HISTORIC LANDMARK COMMISSION
JANUARY 27, 2020
APPLICATION FOR A CERTIFICATE OF APPROPRIATENESS
LHD-2019-0031
607 OAKLAND AVENUE
SMOOT/TERRACE PARK HISTORIC DISTRICT

PROPOSAL

Currently proposed; staff does not support:

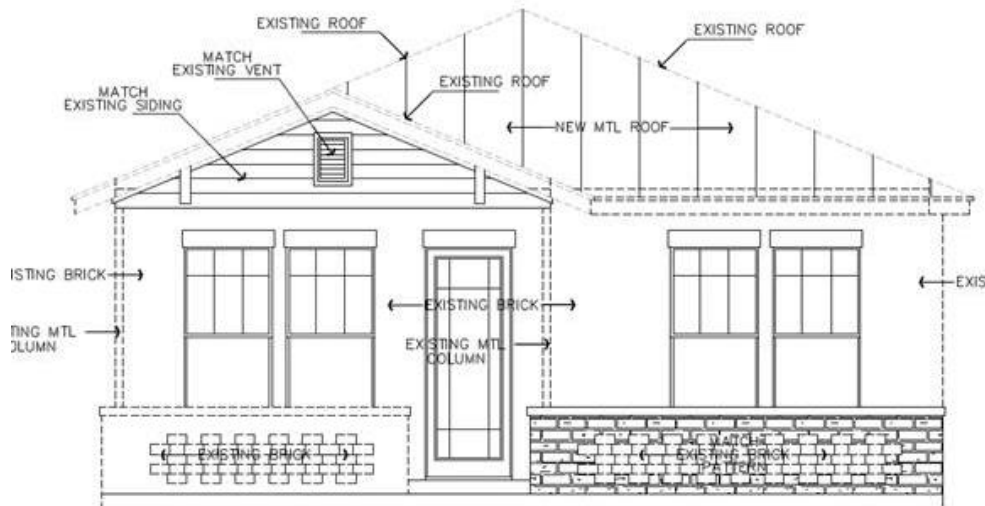
The proposed project extends the covered front porch to be full-width, creating a false sense of history. Previously, the applicant proposed to construct an uncovered patio with low brick walls on the right side of the primary façade, a change that would be discernible as new. The proposed full-width porch does not meet this standard, but the patio would.

The proposed project extends the covered porch and front-gabled porch roof to be full-width. The project does not meet this standard.

1. Approve the plans, with the exception of the front porch extension and the new window opening on the front wall.
2. Consider the proposed raising of the house by 2'.
3. Allow staff to administratively approve the previously proposed construction of an uncovered patio with low brick walls if the applicant revises the currently proposed plans.
